# Service Bulletin

Bulletin No.: 23-NA-074

**Subject:** Service Engine Soon (SES), Reduced Power, Service Brake, Reduced Steering and/or Stabilitrak Message Illuminated on Driver Information Center (DIC), DTCs P0232, P023F, P0641, P0651, P06A3, P0697, P07BE, P1000, P1009, P2535, P129D, P12A6, P12A8, P2635, P3051, P3052, P3055, P3056, P305B, U0074, U0077, U0121, U0131, U0151, U0415, U0420, U0672, U111A, U18A2, U18C6, U18D2, U2502, U2616 Set

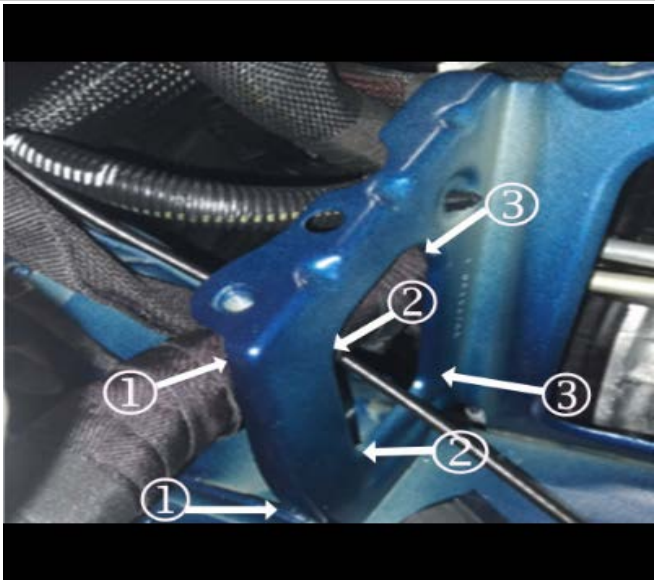
This condition may be caused by wire chafing on the battery tray support bracket.
